ALASKAN WAY VIADUCT

EVALUATION OF GRAY'S RETROFIT PROPOSAL

Prepared for the
Washington State Department of Transportation

By
T.Y. Lin International

Figure 2a, Longitudinal auxiliary frame per Gray's proposal

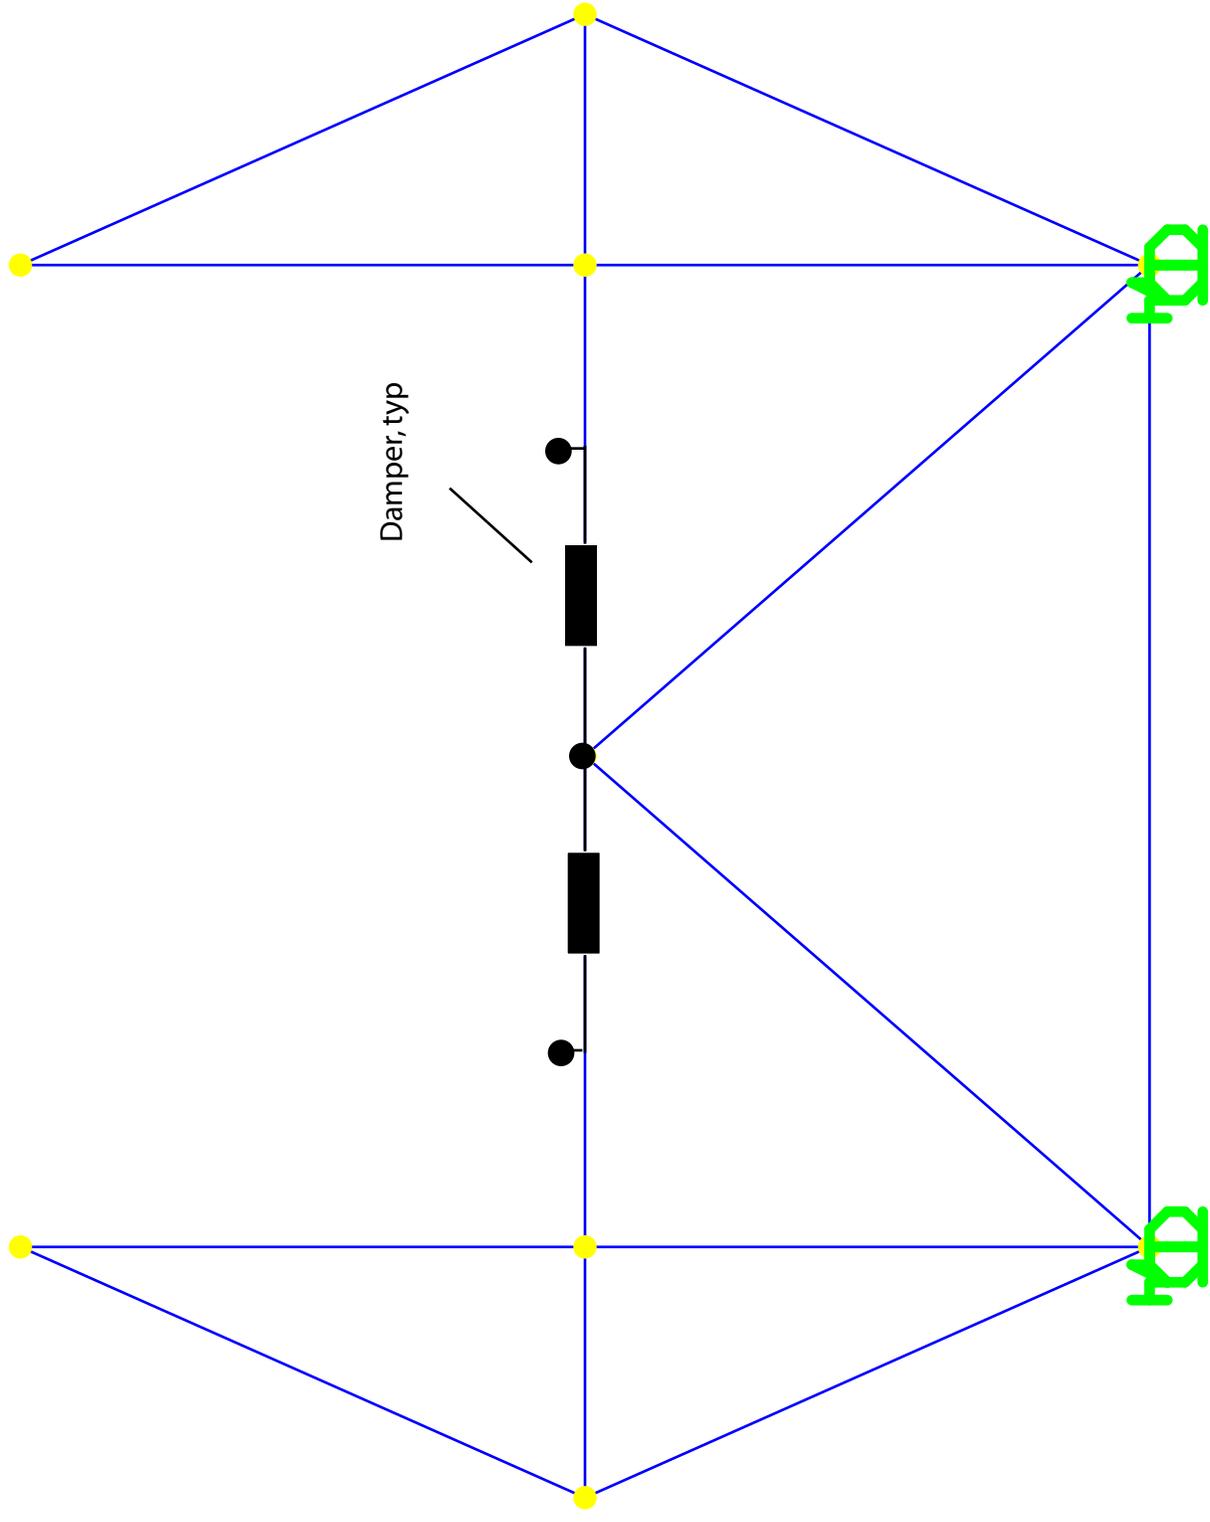
Gray's initial proposal is included in Appendix B of this report. The proposal includes two longitudinal structural steel frames and two transverse structural steel frames per three-bay unit of the structure. Both types of frame are illustrated in Figure 2.

Figure 10a Drift of retrofitted structure, rare earthquake, longitudinal direction

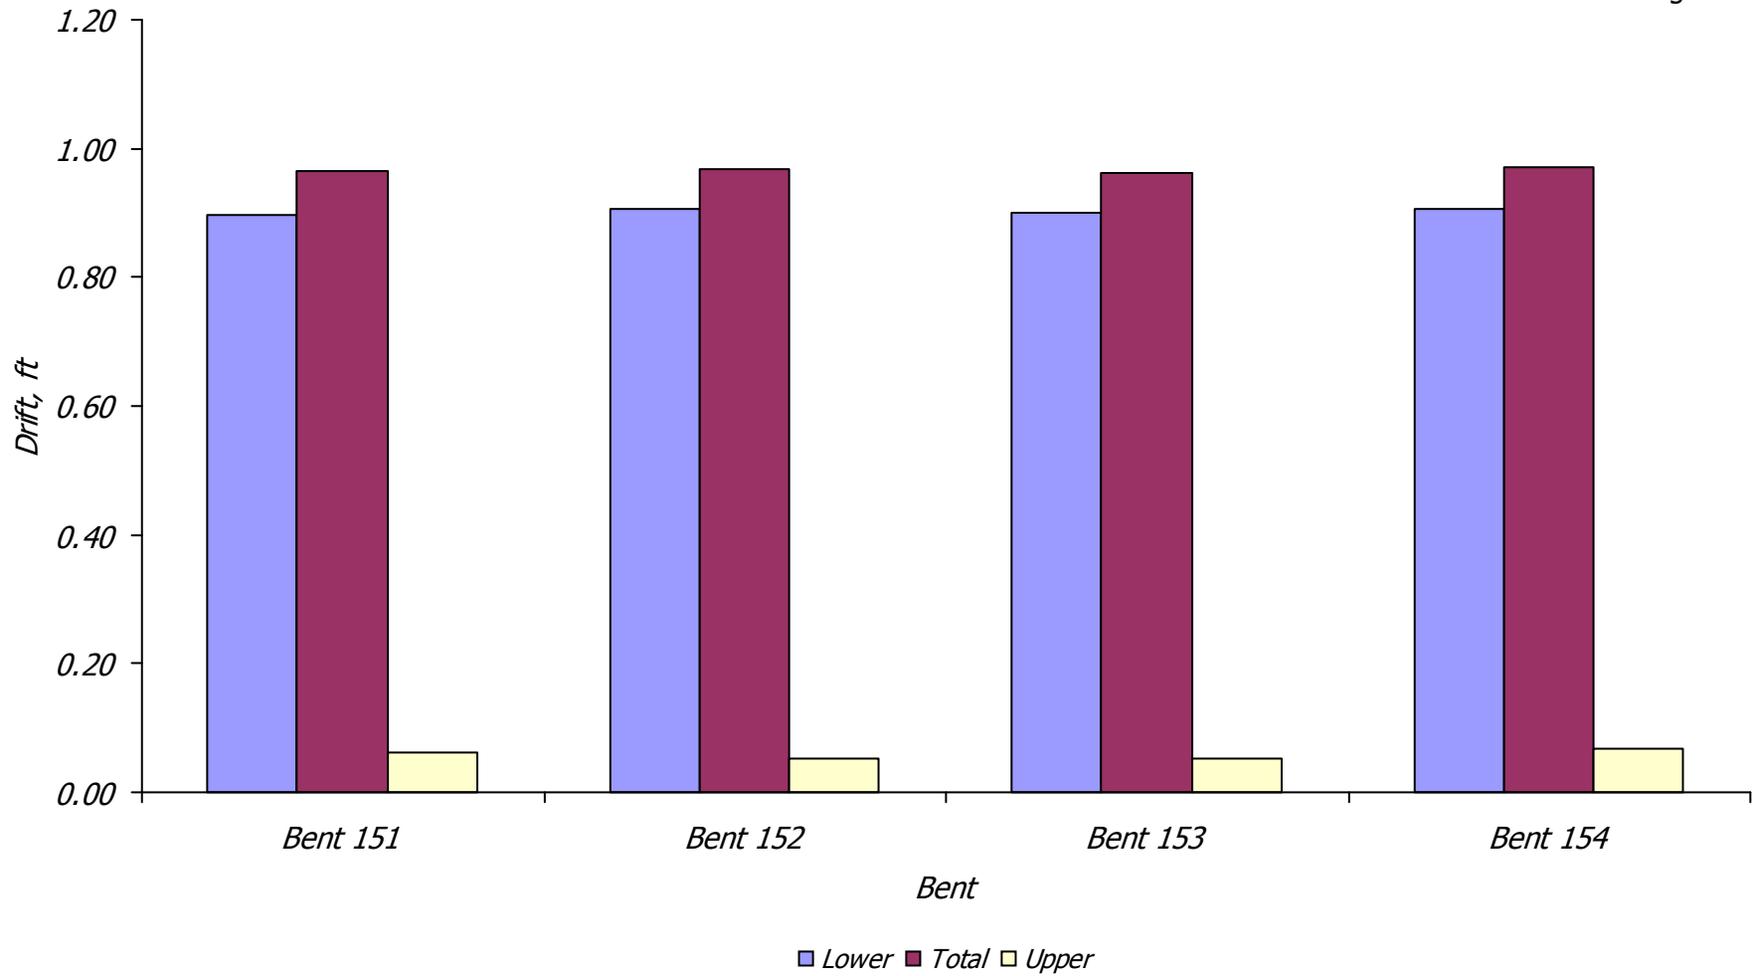
For the rare earthquake, the drift of the retrofitted structure is summarized in Figure 10.⁶ This shows the peak relative displacement of the lower level of the structure with respect to the foundation, the peak relative displacement of the upper level of the structure with respect to the lower level, and the peak relative displacement of the upper level of the structure with respect to the foundation. The drift in the longitudinal direction is concentrated into the lower level of the structure. The upper stories of the longitudinal auxiliary frames are braced, and they restrain the drift of the upper level of the structure.

Figure 14a Column curvature ductility demand, retrofitted structure, rare earthquake, longitudinal direction

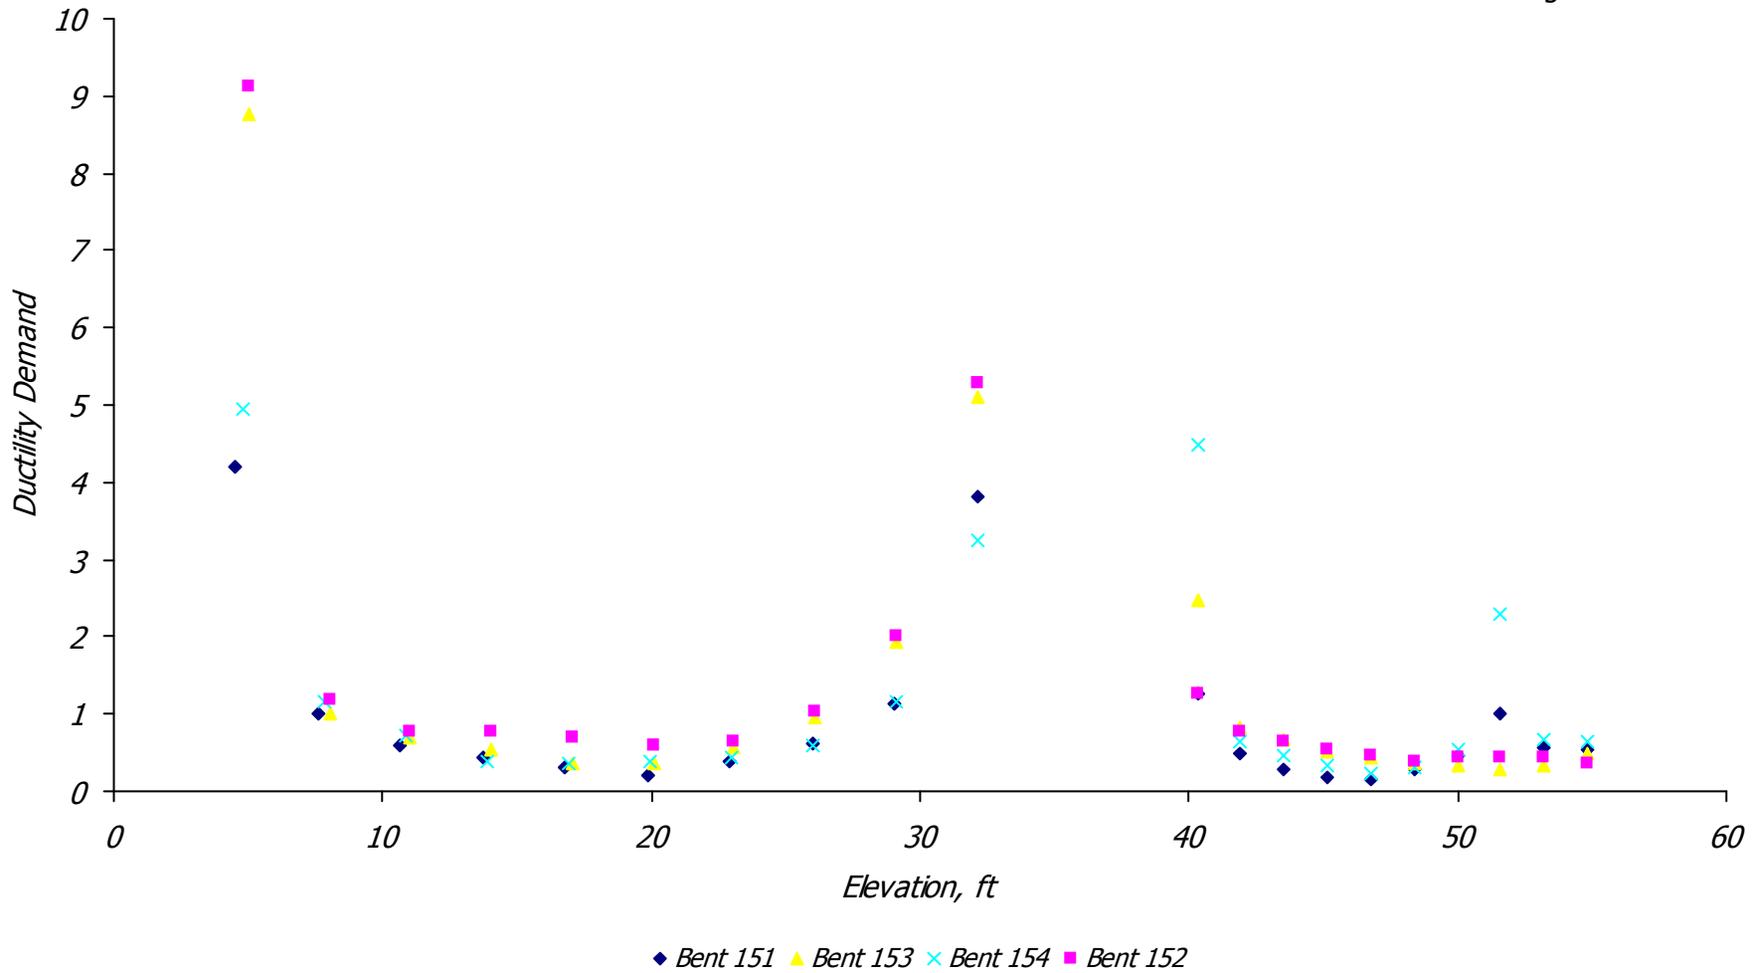
For the rare earthquake, the curvature ductility demands on the columns are summarized in Figure 14. The plots show that plastic hinges form in the tops and bottoms of the columns, in both levels of the structure and in both directions. In the upper level columns of the end bents, the hinges don't form at the very tops of the columns because there is additional main reinforcement at this location. The hinges form at a weaker section a few feet from the tops of the columns.

Figure 15 Column curvature versus axial force, retrofitted structure, rare earthquake, end bents

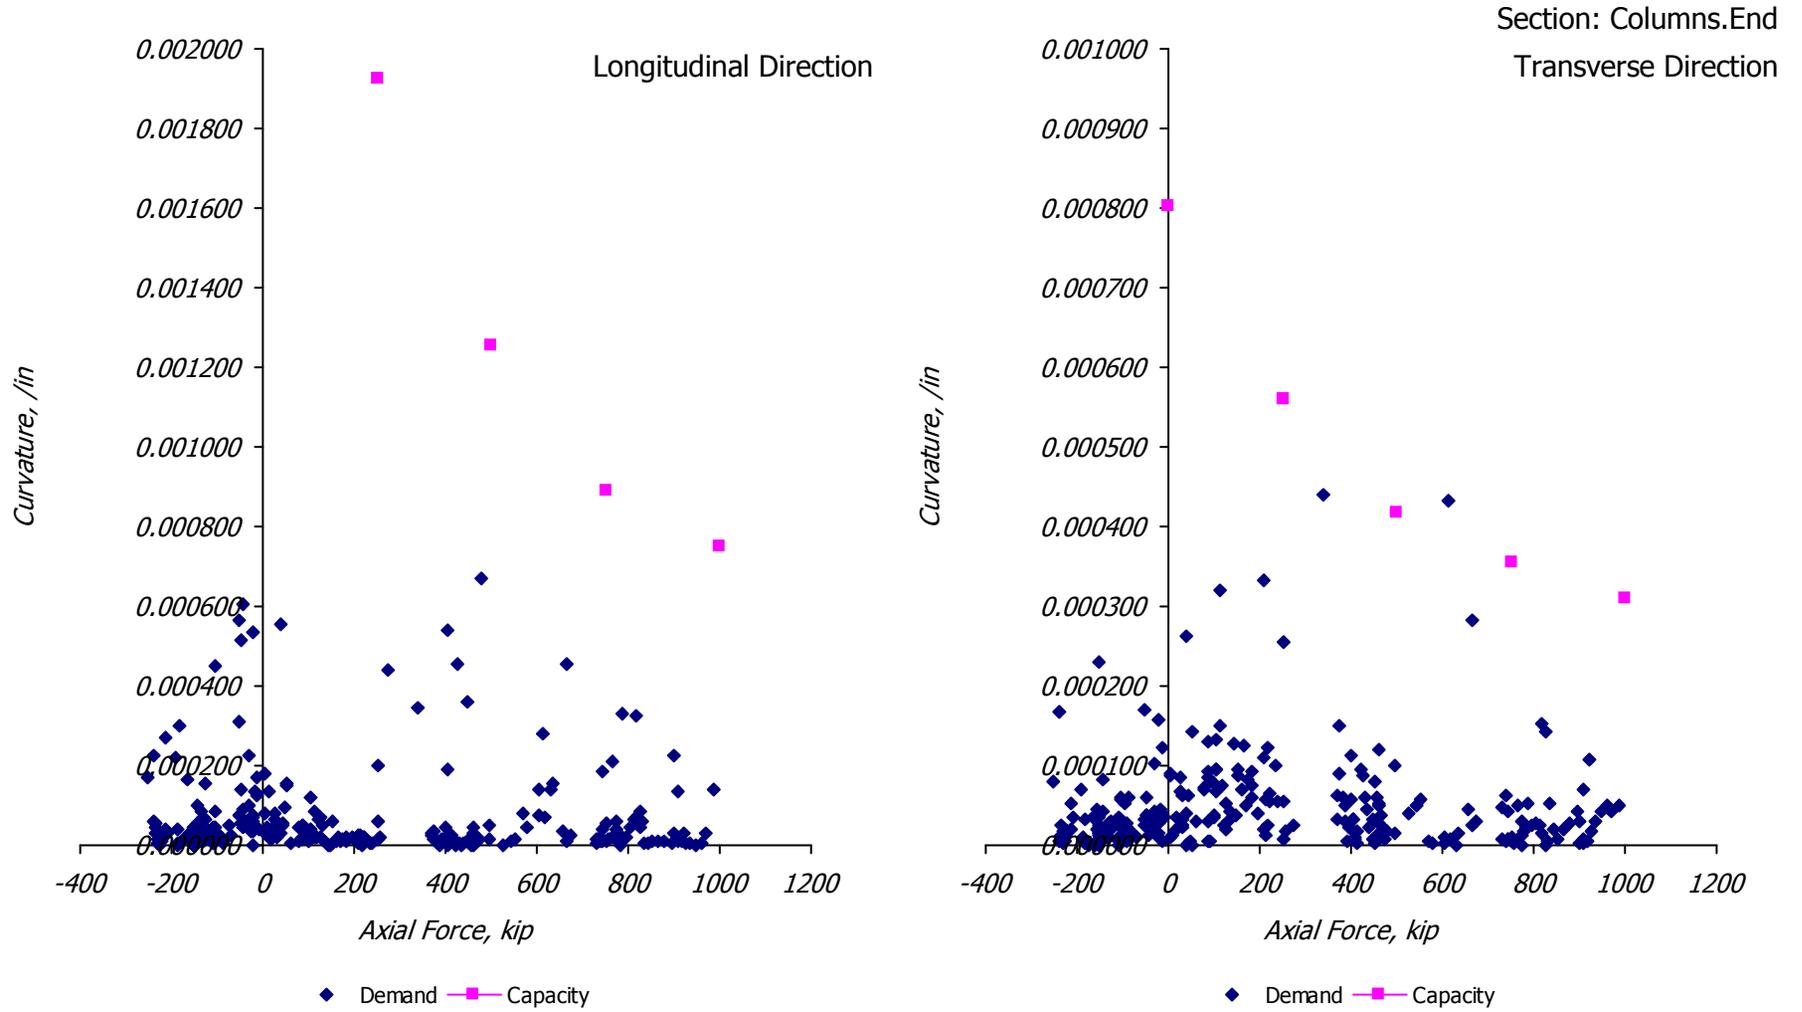
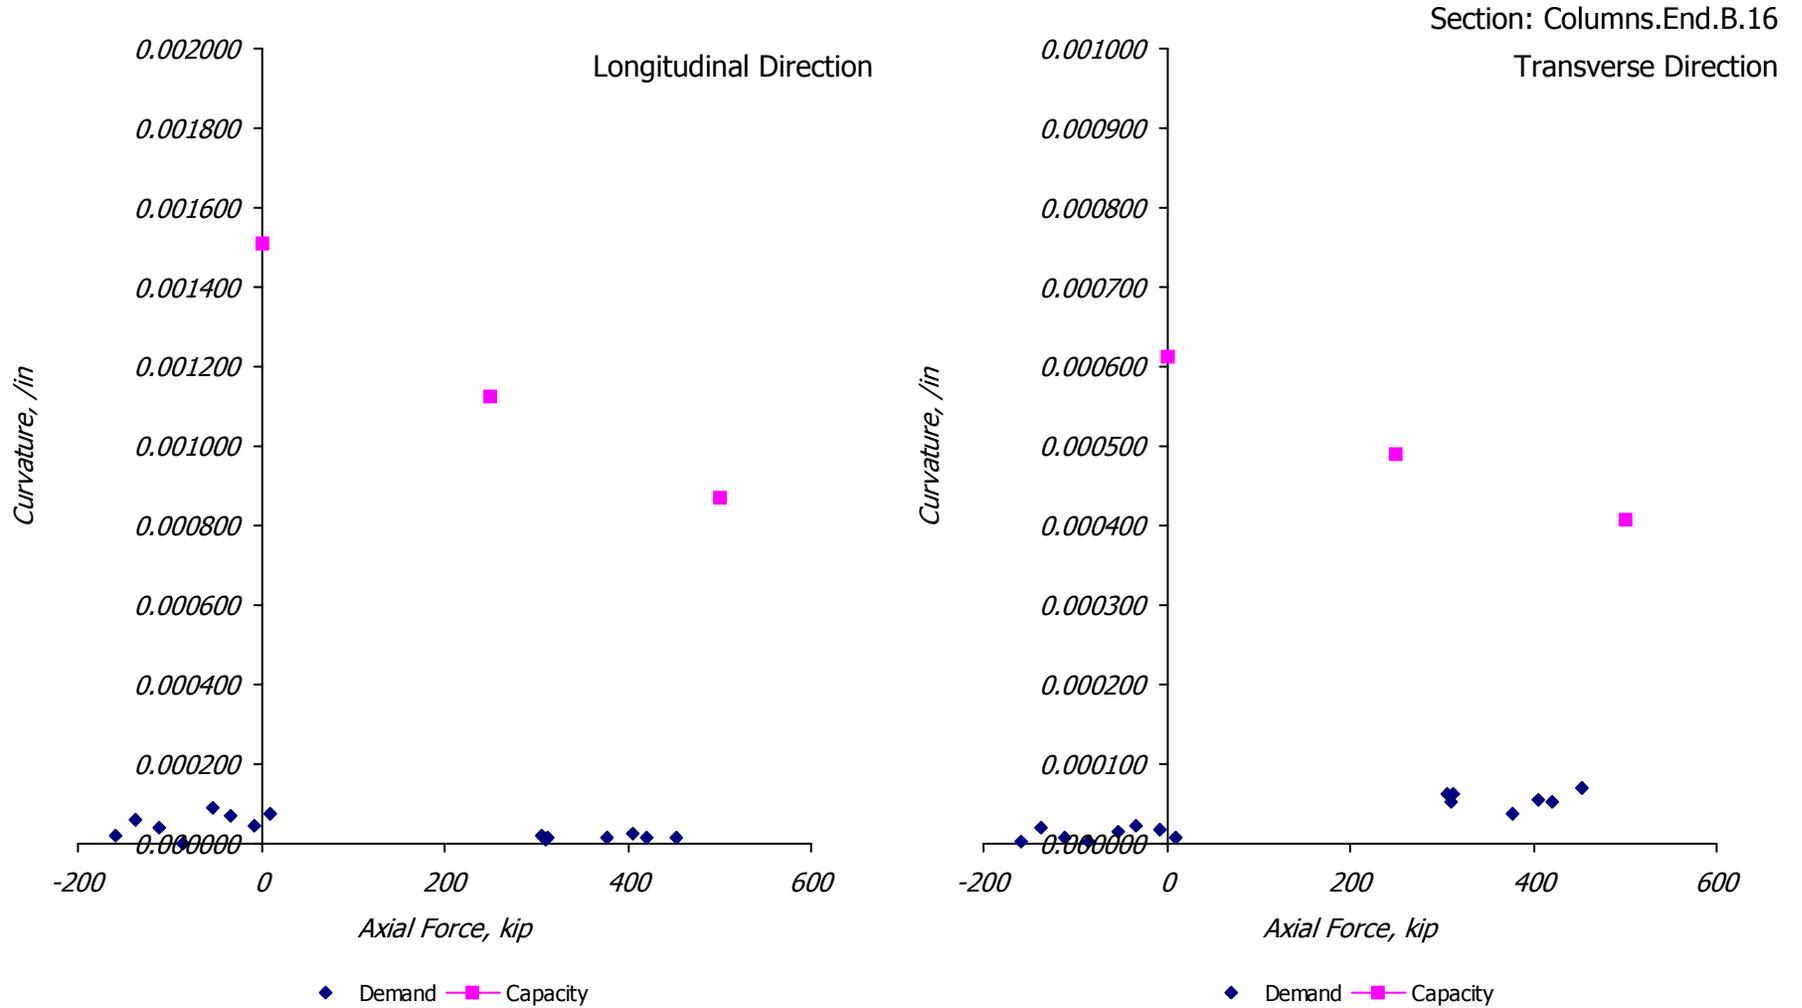
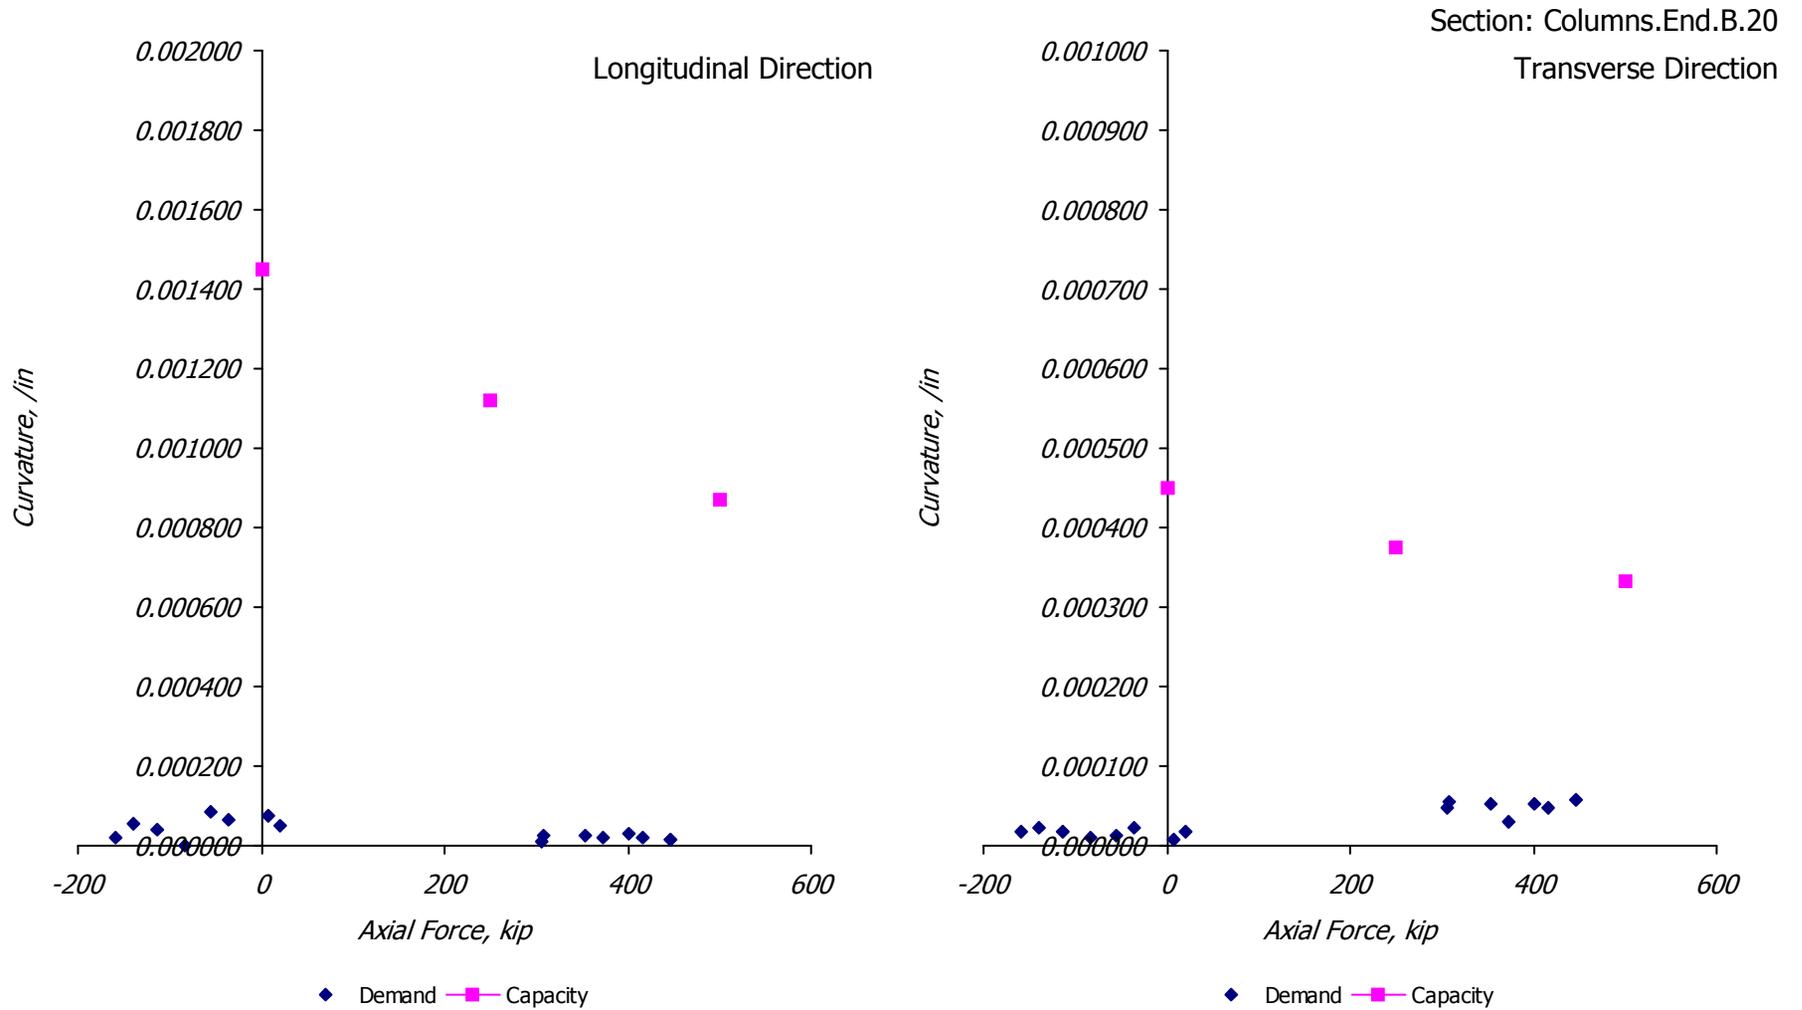
Figure 15 shows that the flexural demands on the end columns slightly exceed the capacity in the transverse direction, for the section designated "Columns.End" (the typical section). Figure 16 shows that the flexural demands on the middle columns slightly exceed the capacity in the longitudinal direction, for the section designated "Columns.Middle" (the typical section). A closer look reveals a more insidious problem, however. The axial forces on the middle columns are very high, over 3500 kip, which is equivalent to a stress of about $0.4 f'_c$. These forces are caused by rocking of the structure and impact of the columns and footings against the piles.
